UNITED STATES
DEPARTMENT OF THE INTERIOR
BUREAU OF LAND MANAGEMENT

FORM APPROVED
OMB NO. 1004-0135
Expires: July 31, 2010**SUNDRY NOTICES AND REPORTS ON WELLS**
*Do not use this form for proposals to drill or to re-enter an abandoned well. Use form 3160-3 (APD) for such proposals.***SUBMIT IN TRIPLICATE - Other instructions on reverse side.**

1. Type of Well <input checked="" type="checkbox"/> Oil Well <input type="checkbox"/> Gas Well <input type="checkbox"/> Other		8. Well Name and No. DICKENS 29 FEDERAL 4H
2. Name of Operator DEVON ENERGY PRODUCTION CO LP Contact: SPENCE A LAIRD Email: spence.laird@dvn.com		9. API Well No. 30-015-38285-00-X1
3a. Address 20 NORTH BROADWAY STE 1500 OKLAHOMA CITY, OK 73102	3b. Phone No. (include area code) Ph: 405-228-8973	10. Field and Pool, or Exploratory DOG CANYON
4. Location of Well (Footage, Sec., T., R., M., or Survey Description) Sec 29 T16S R28E NENE 840FNL 330FEL		11. County or Parish, and State EDDY COUNTY, NM

Conventional Rig Location Layout

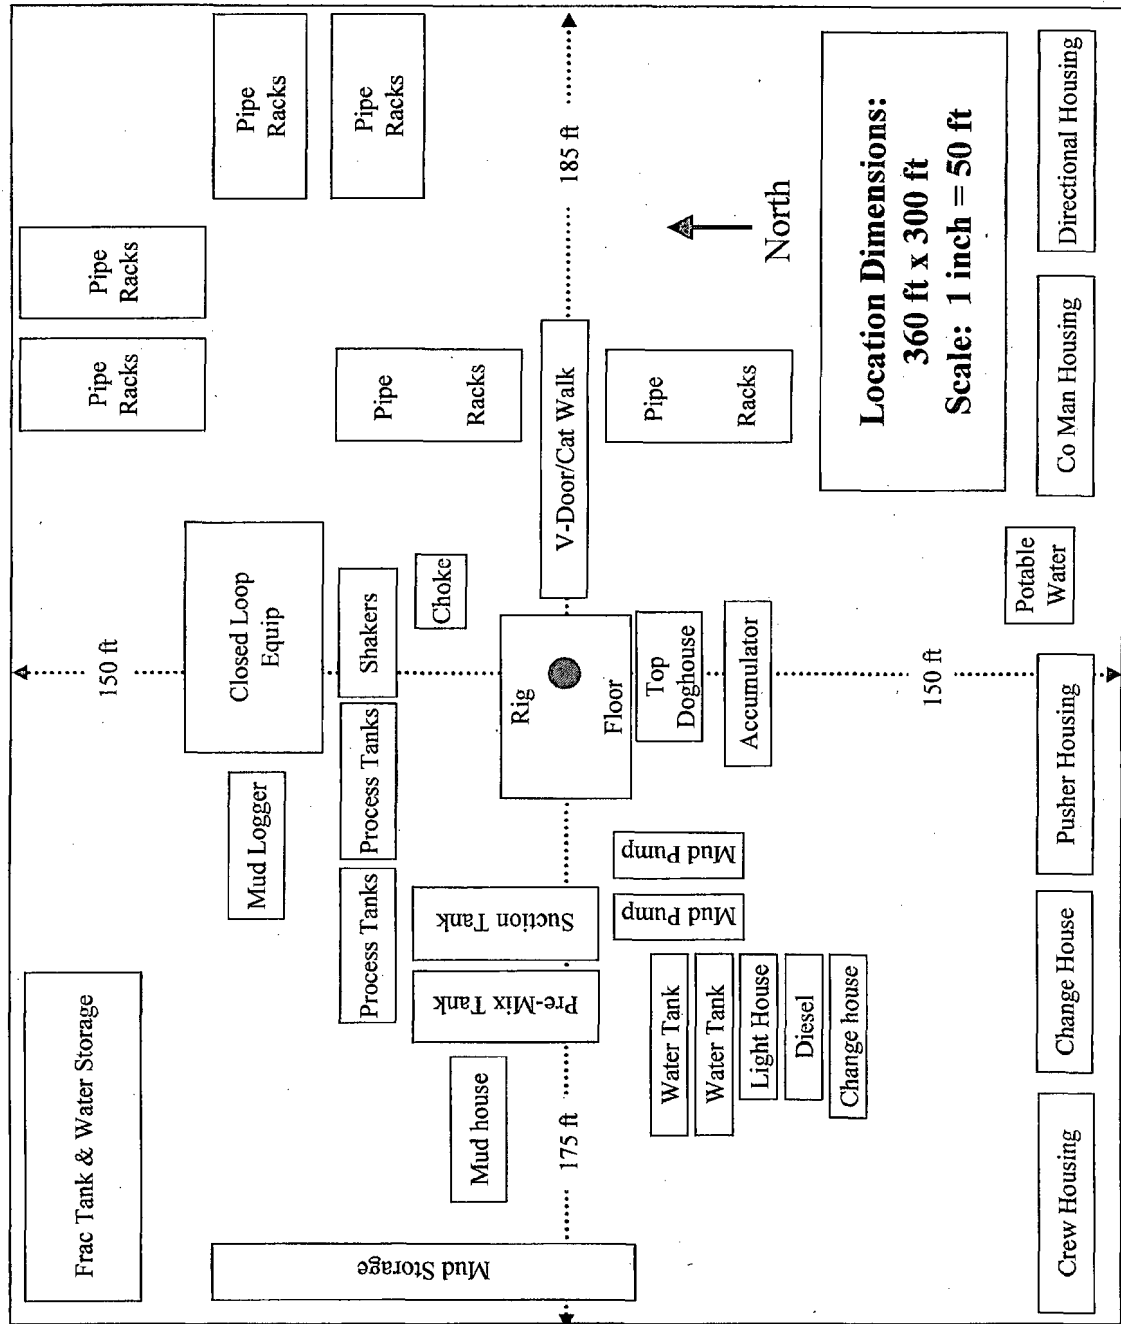
Devon Energy Production Company, LP respectfully requests to change the rig drilling the Dickens 29 Federal 4H from the originally permitted rig and location layout to the Patterson Rig #41 and a location layout of 360' x 300' (please see attached rig/location layout). Patterson Rig #41 will also use a 13 5/8" 2M BOP while drilling the intermediate hole (450' - 2300', 11" hole & 9 5/8" csg) then switch to a 11" 5M BOP while drilling the production hole (450'-10,920', 8 3/4" hole & 5 1/2" csg). Please see attachments for further details.
